CITY COUNCIL MEETING

Thursday, September 17, 2026 at 6:30 PM
Council Chambers, 60 West Main, Hyrum, Utah

Subject: West Point Dairy Products, Receiving and Warehouse Expansion – Seeking site plan approval from the City Council for receiving and warehouse expansion located at 570 North 500 West.

STAFF COMMENTS – Fourth Review

See Sheet T1.1PHA

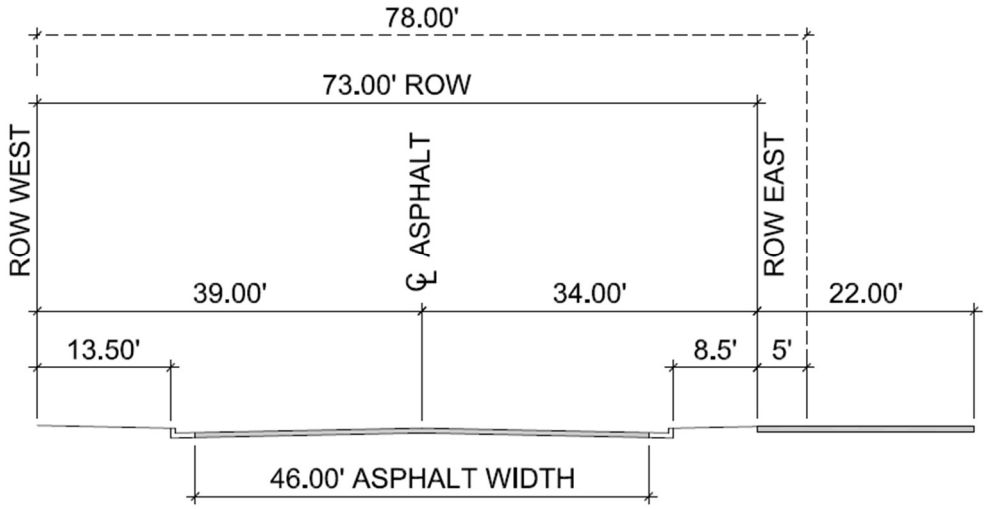
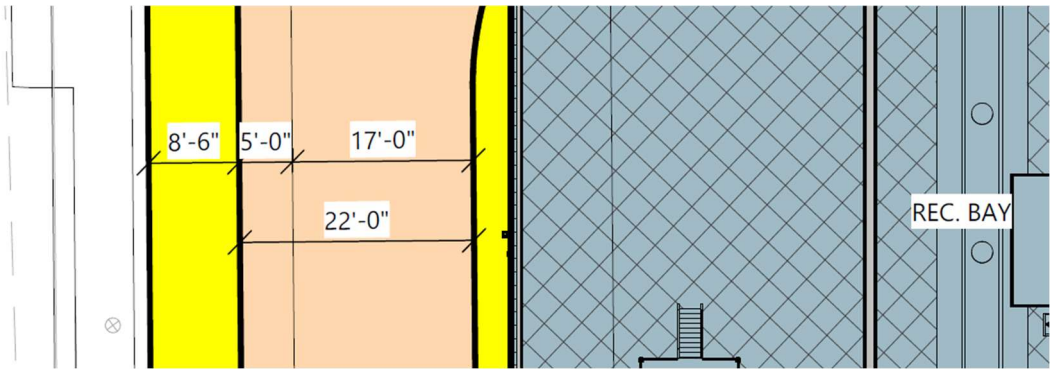
1. In a collaborative effort between Hyrum City and WPD for WPD to comply with HCC 17.49.080, staff is recommending the Planning Commission and City Council approve the following right-of-way width reductions abutting the WPD project:
    a. 500 West right-of-way be reduced from 78.00’ feet to 71.00’ feet; and

b. 700 North right-of-way be reduced from 78 feet to 73 feet.

(13.50’ park strip reduced to 8.5’)

SHEET NUMBER
C2.0

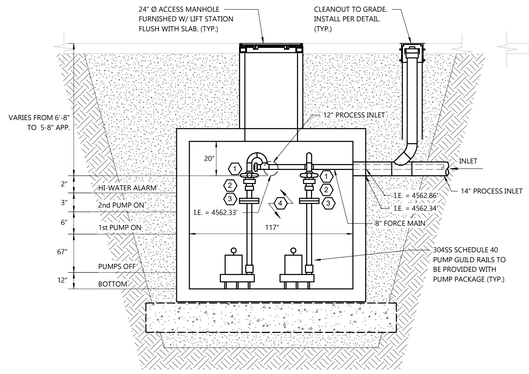
3. Site grading and storm water has also been sent to an engineering firm for storm drain design for 4600 South.
4. On sheet C2.0 please show detail for abandonment of the existing fire line.
5. On sheet C2.0 please show detail for tie in connection for new 8" fire line.
6. Hyrum City recommends looking into a fire pumping system for new and existing buildings with this expansion.

SHEET NUMBER
C3.1

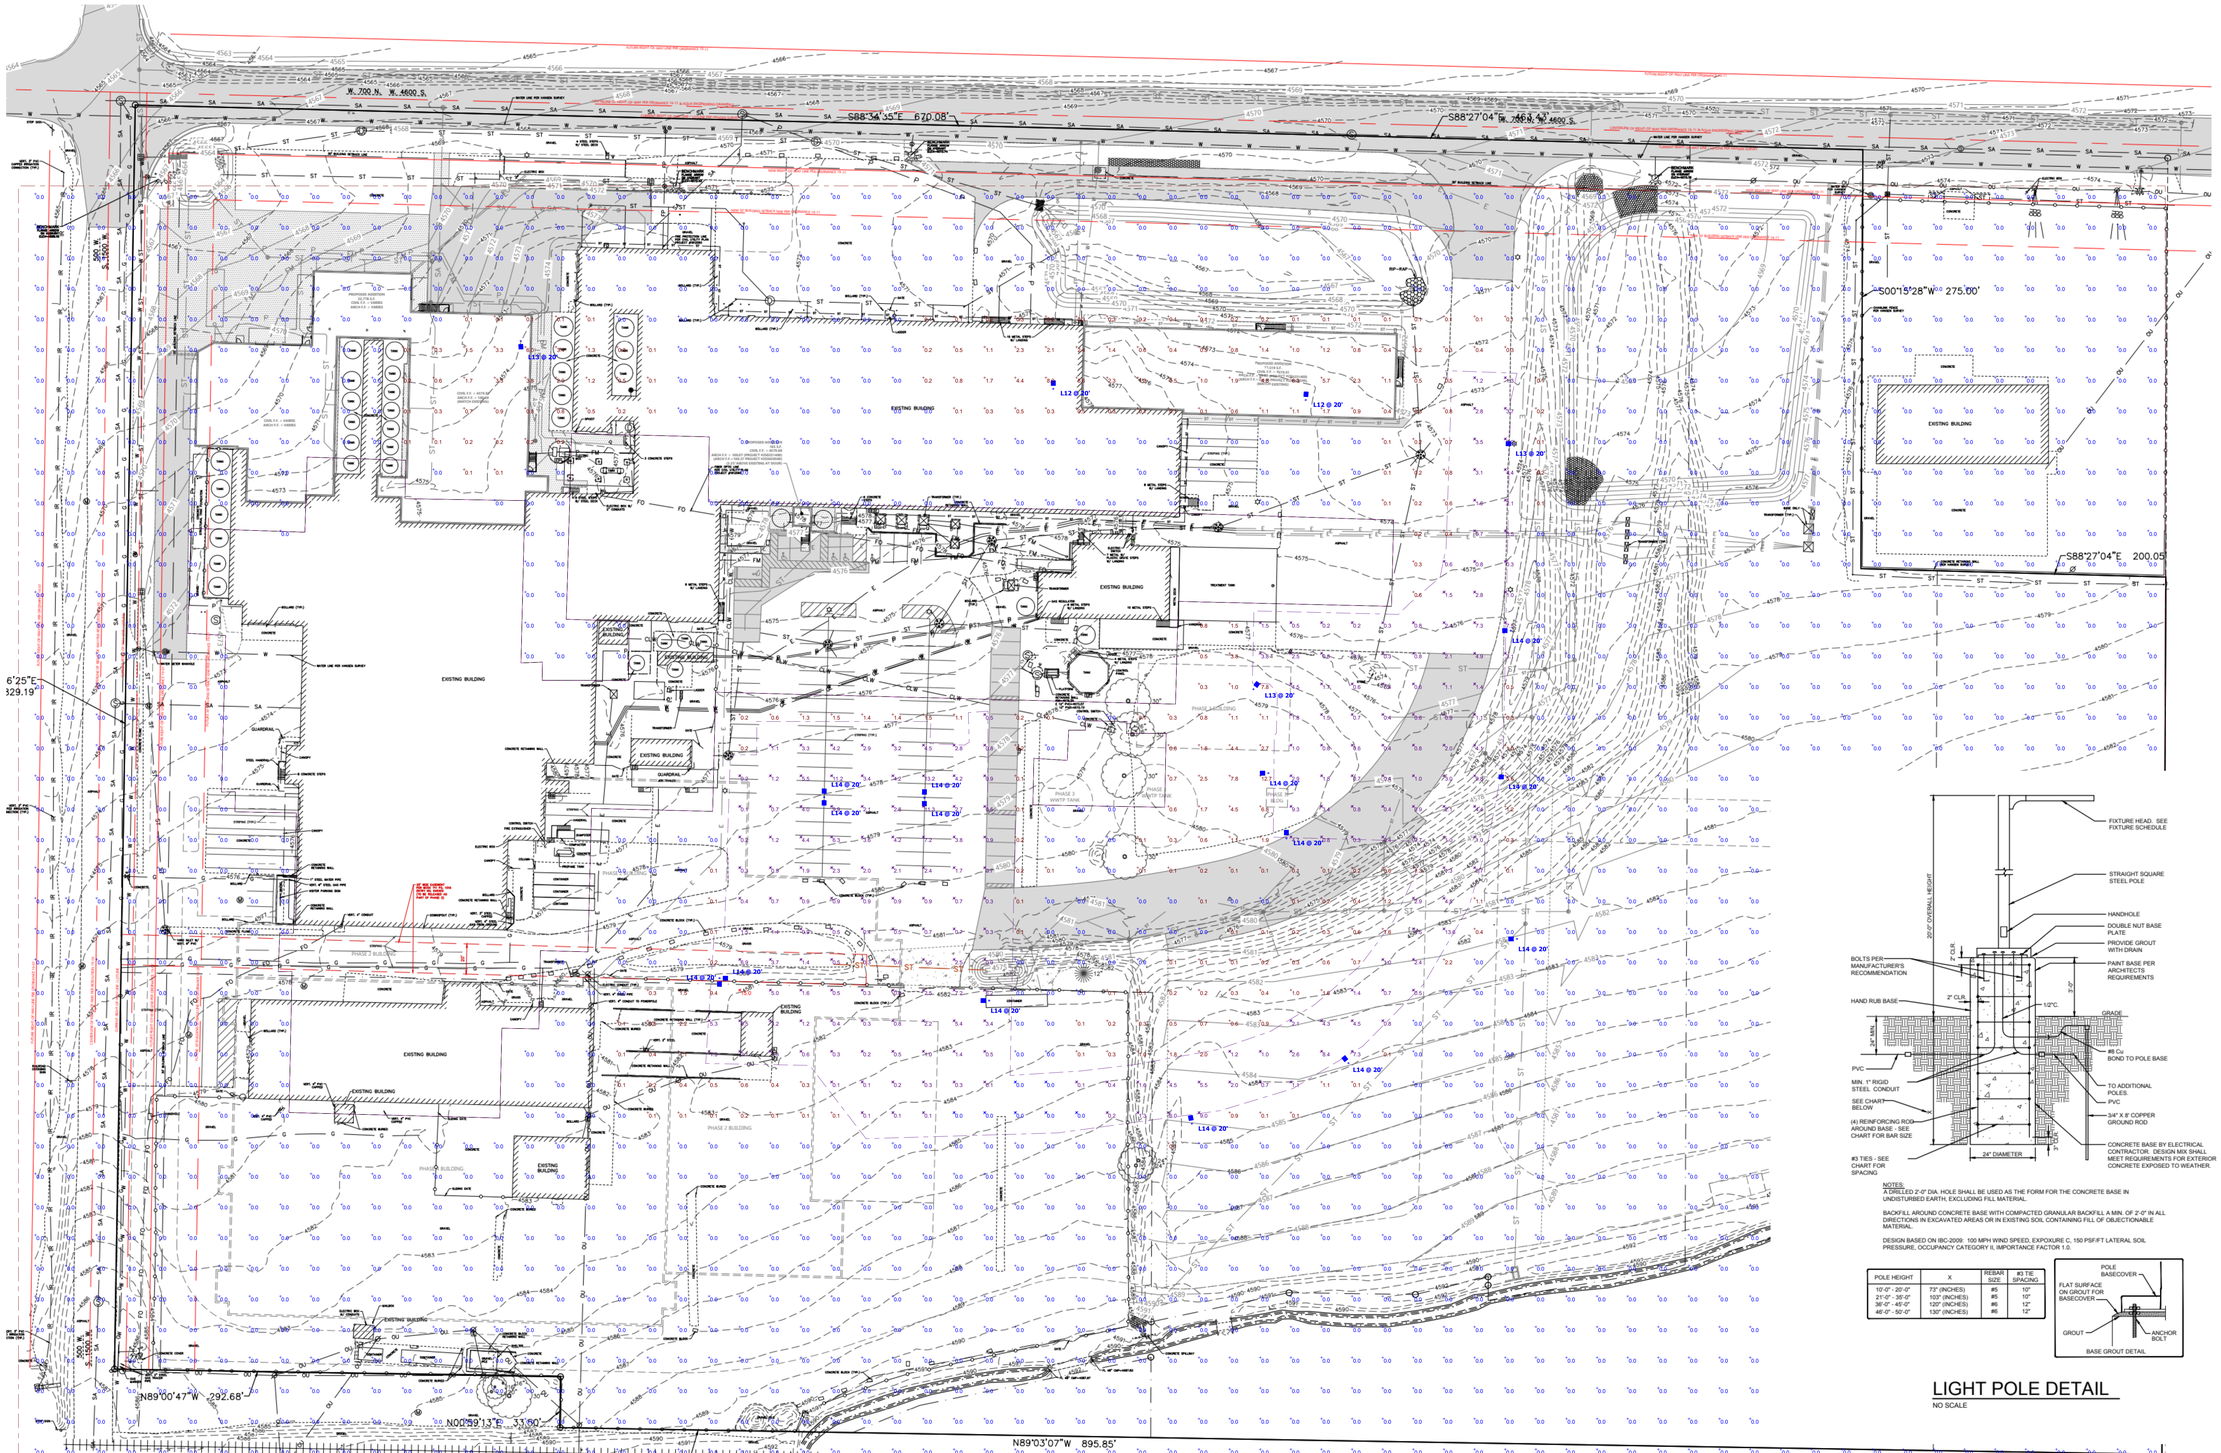
2. HCC 17.49.020 Use Regulations: Food processing/mills is a permitted use in the M-2 Zone.
Excel Response: Understood
3. HCC 17.49.022 Lighting Plan: Sheet C3.1 Civil Site Photometric Plan has been provided for new lighting for the expansion. The lamps in the schedule identify the lamps are to be tilted. Applicant shall verify and comply to this section requiring that all new lighting shall prevent glare onto properties and shall be dark-sky sensitive.
Excel Response: There are no new poles being added as part of this first phase of expansion. Three existing poles are moving slightly to allow for widening of the driveway. The existing poles and light fixtures will be reinstalled at the new locations. Heads will be pointed toward the facility and use cut off fixtures. Maximum light pole height will match existing installation. A light pole detail has been added to Sheet C3.1.

Staff Response: Resolved. The detail provided following the June 16, 2026 discussion is not the detail staff requested. Staff requested specification sheets for each light fixture as Excell provided on Sheet PXP2 of the North Expansion through as separate site plan approval application.
